ADDRESS: 257 S 16TH ST

Proposal: Install aluminum windows

Review Requested: Final Approval

STAFF RECOMMENDATION: Denial, pursuant to Standard 6.

SGRA Project No.: 20-039

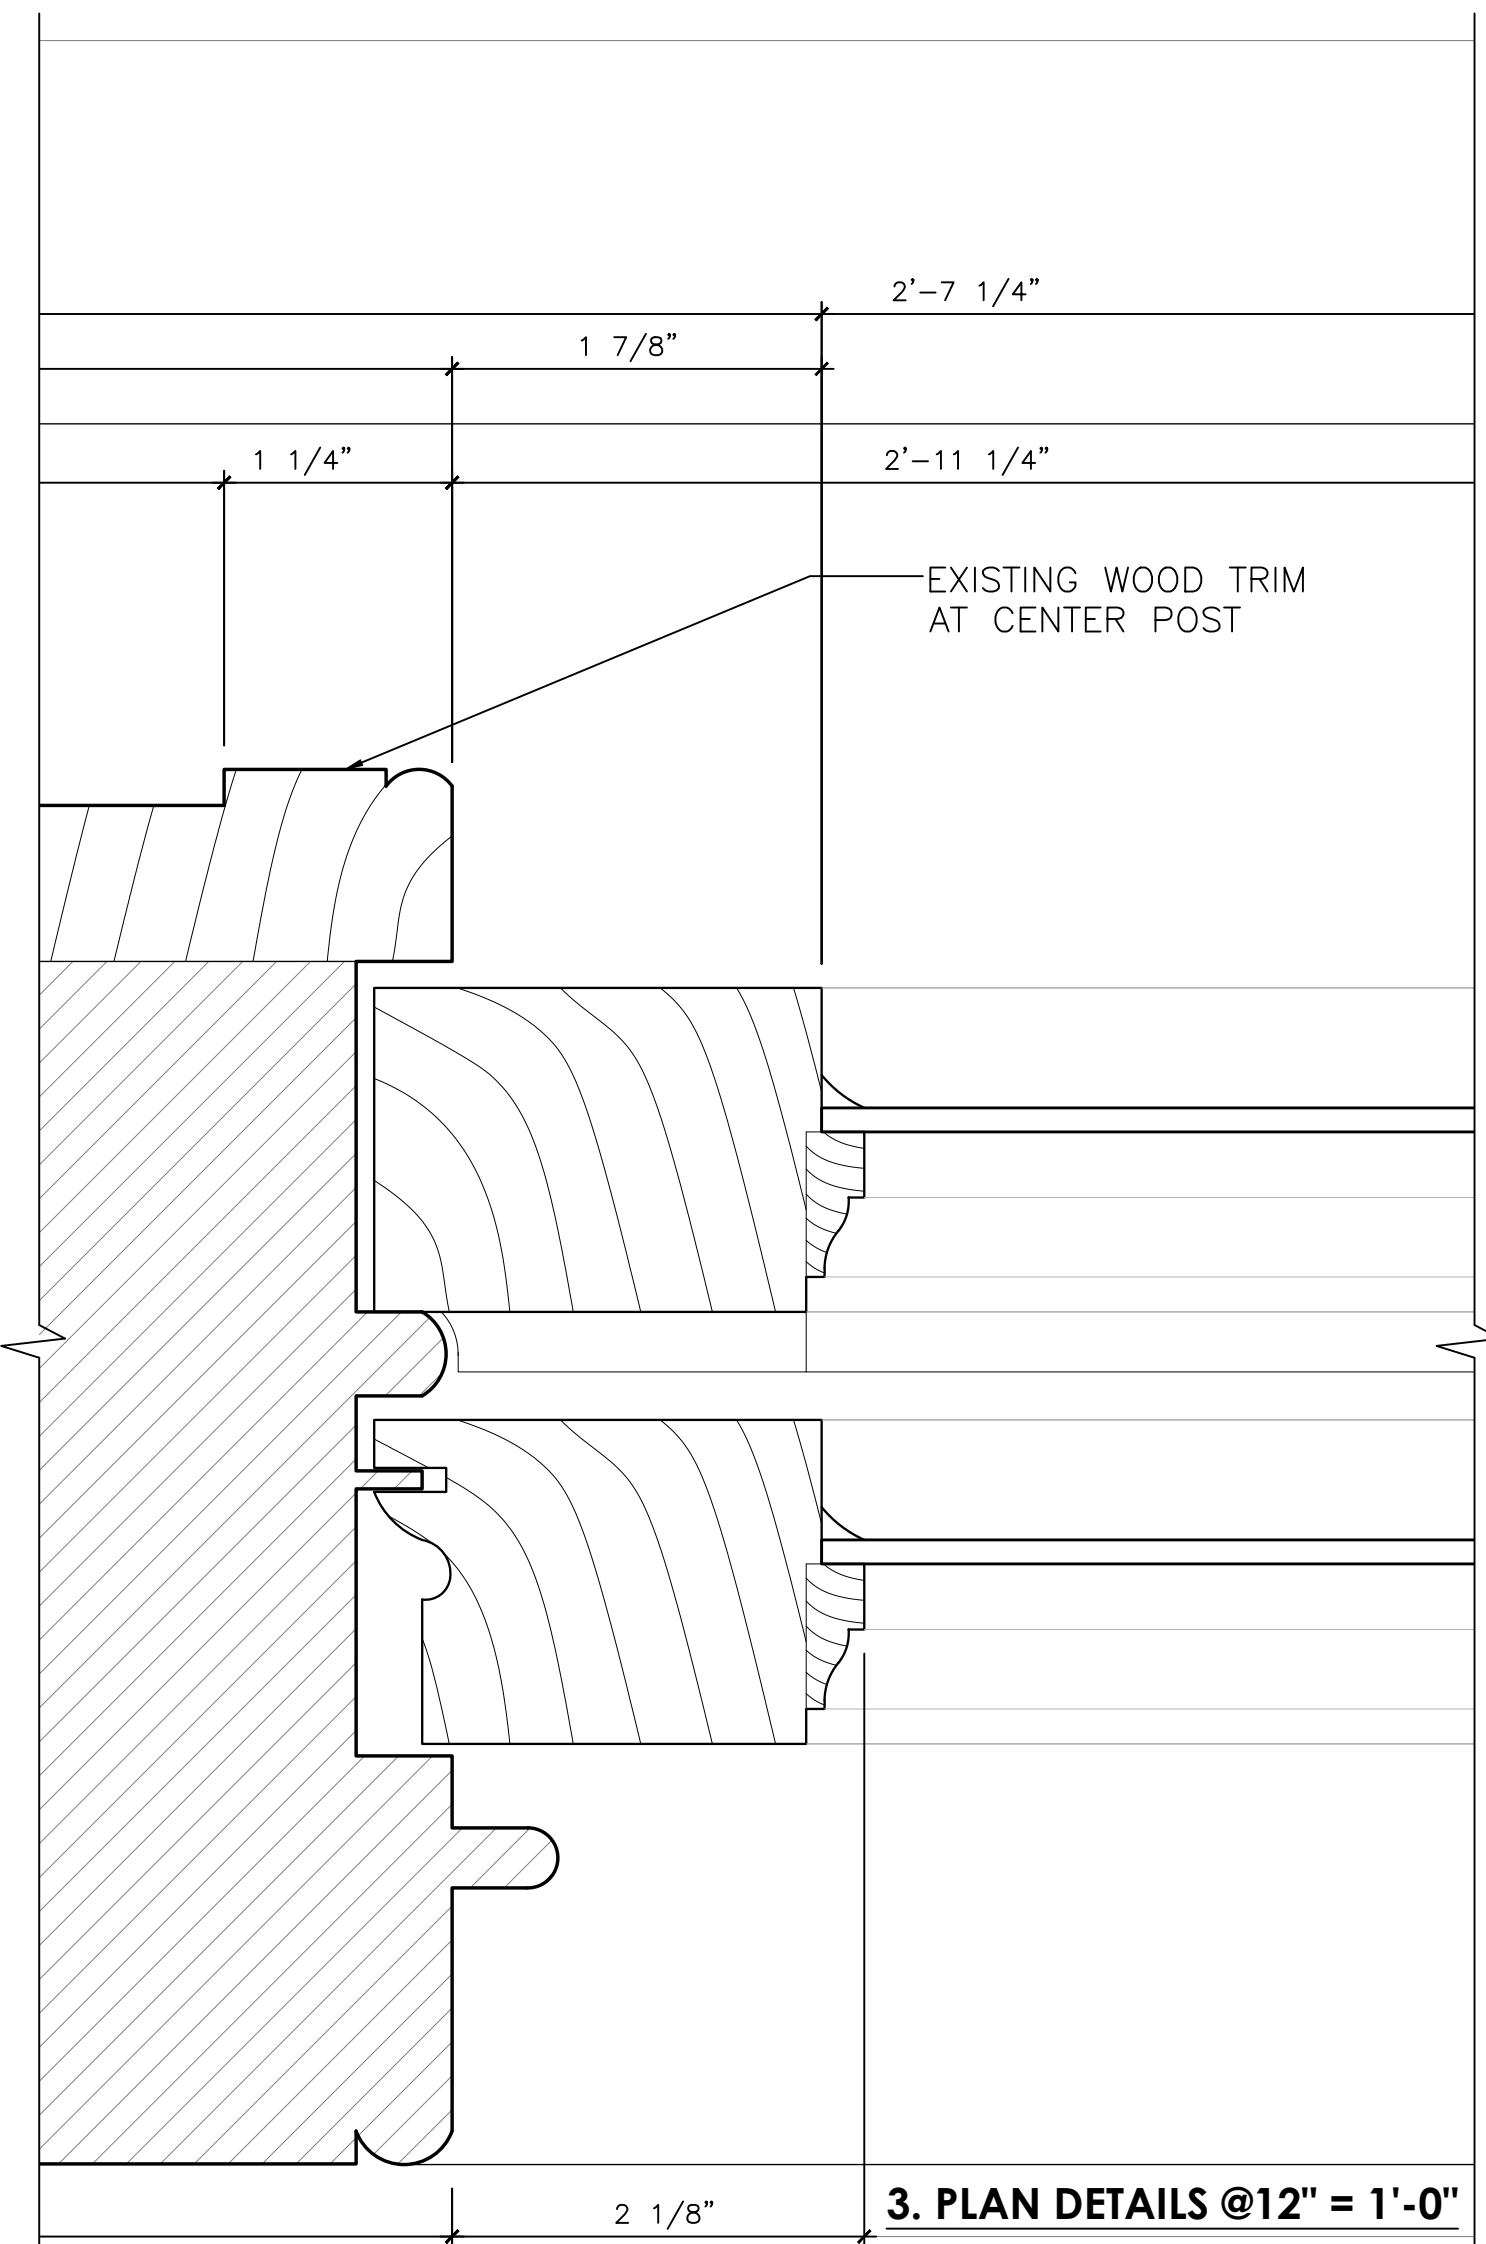
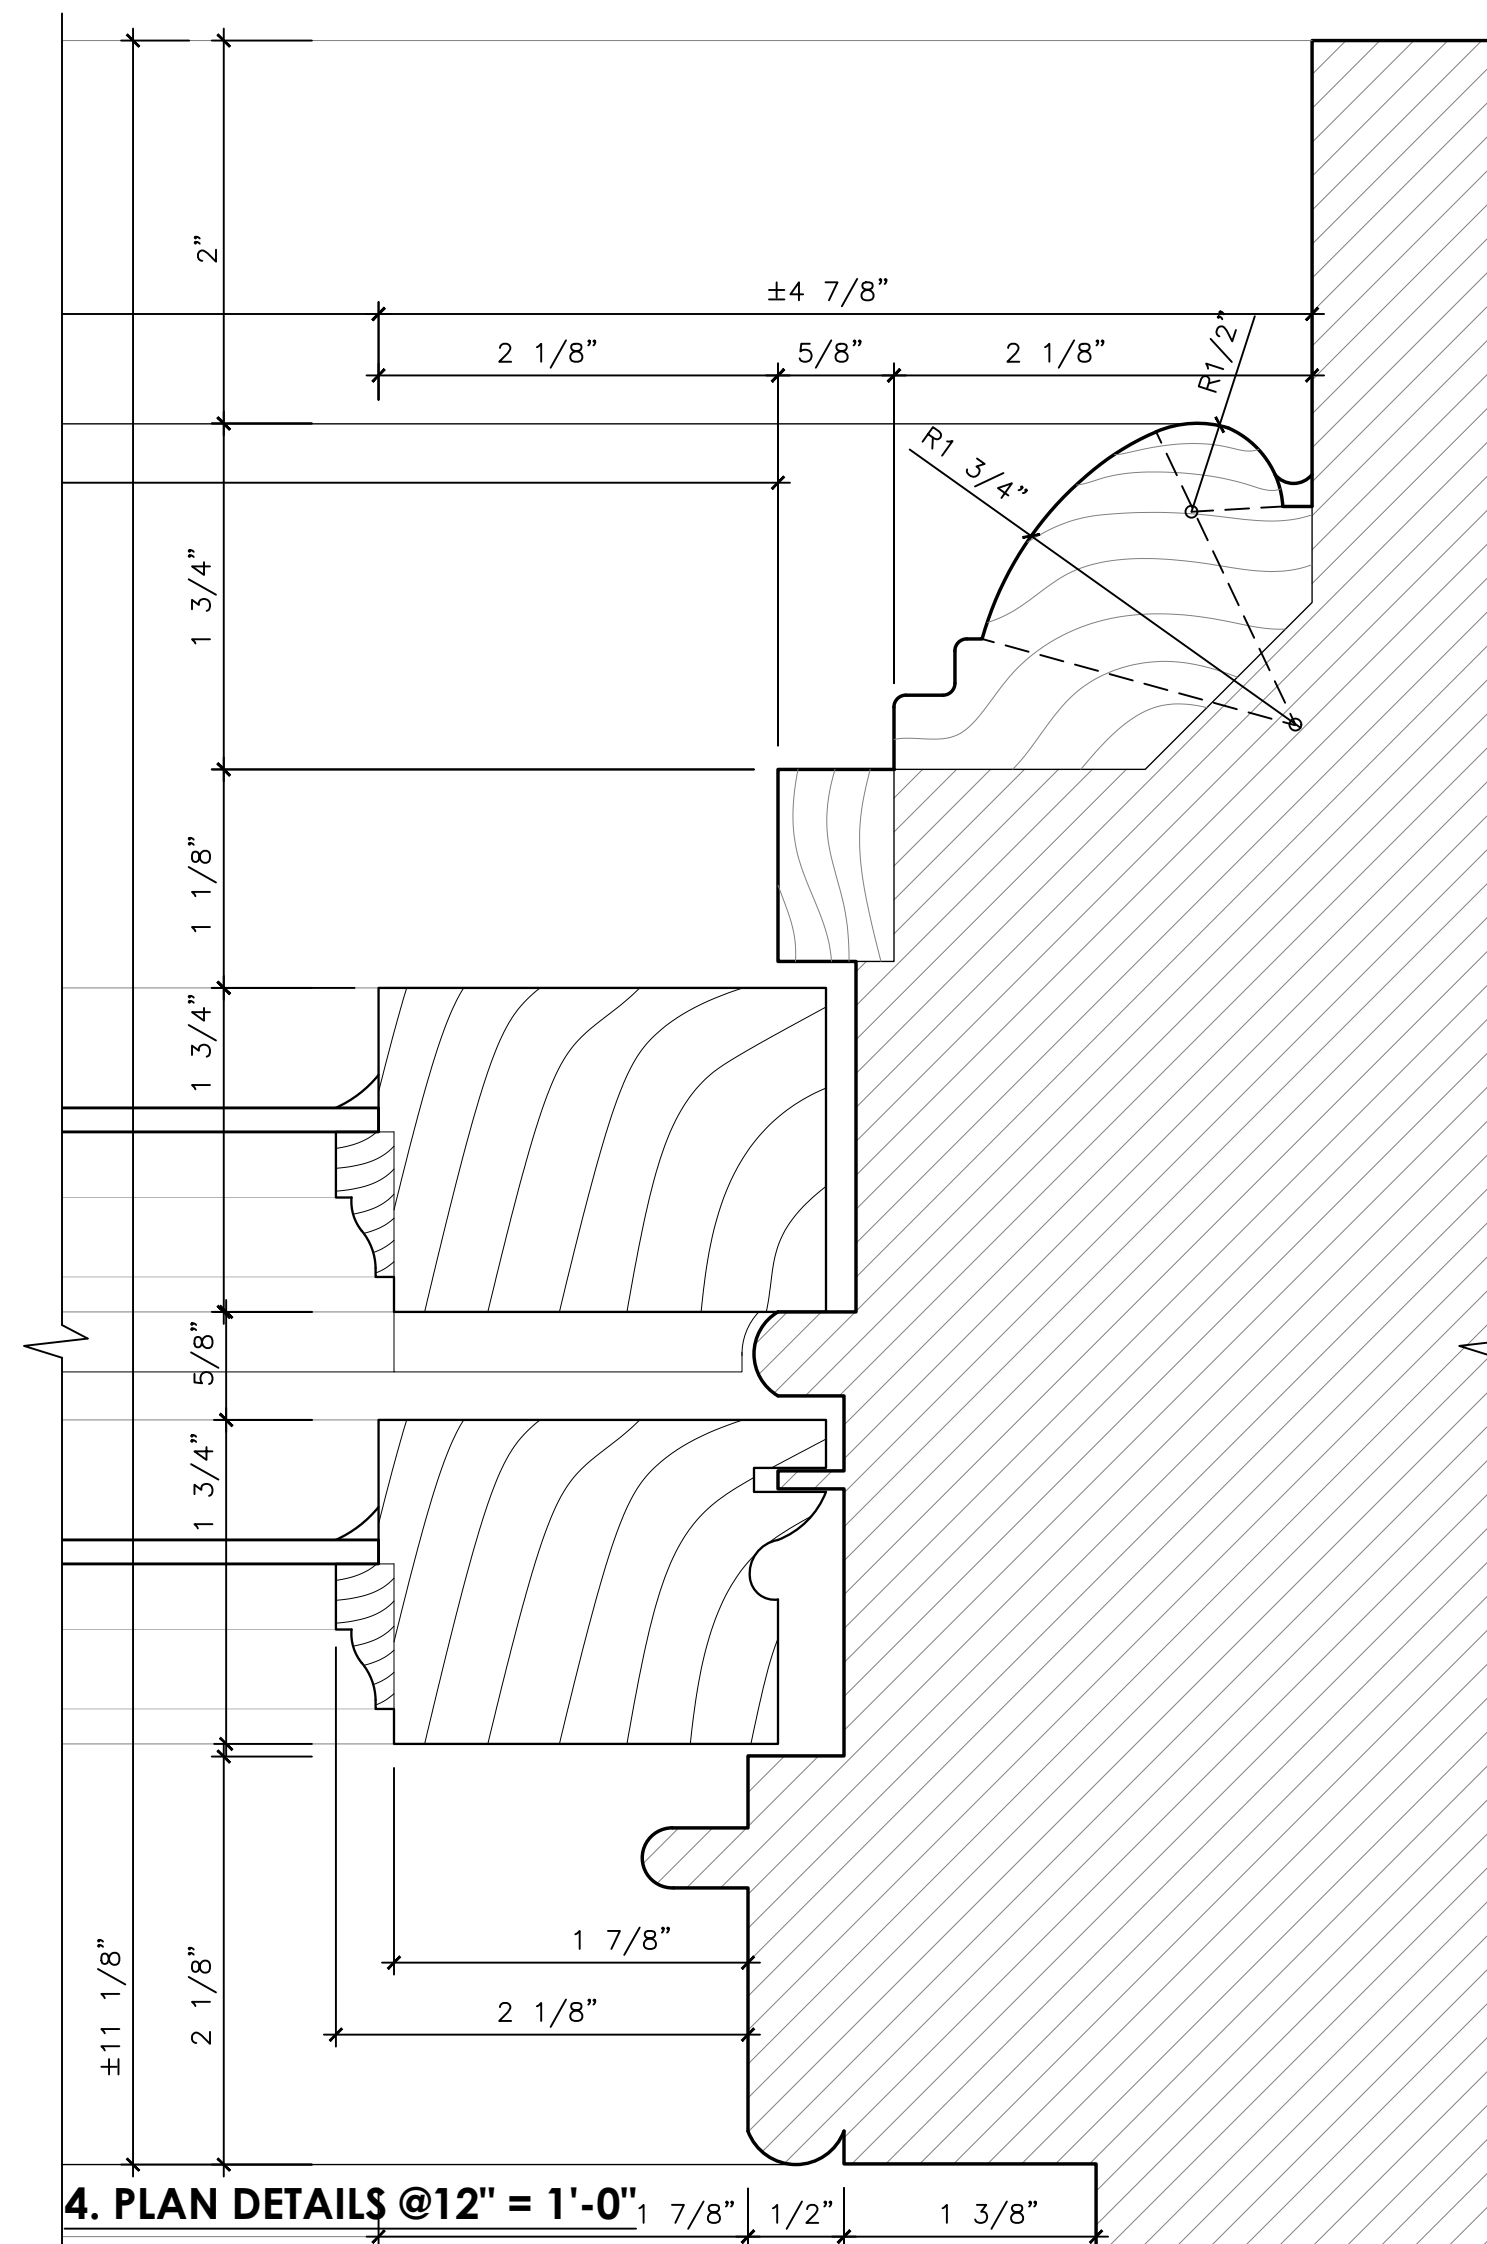
- *Standard 6: Deteriorated historic features shall be repaired rather than replaced. Where the severity of deterioration requires replacement of a distinctive feature, the new feature shall match the old in design, color, texture, and other visual qualities and, where possible, materials. Replacement of missing features shall be substantiated by documentary or pictorial evidence.*
 - o The proposed aluminum system has a significantly flatter profile between the sash and the glazing, changing the spatial relationships and visual qualities as well as texture of the original windows. The proposed aluminum windows do not replicate the appearance of the historic wood windows, failing to satisfy Standard 6.
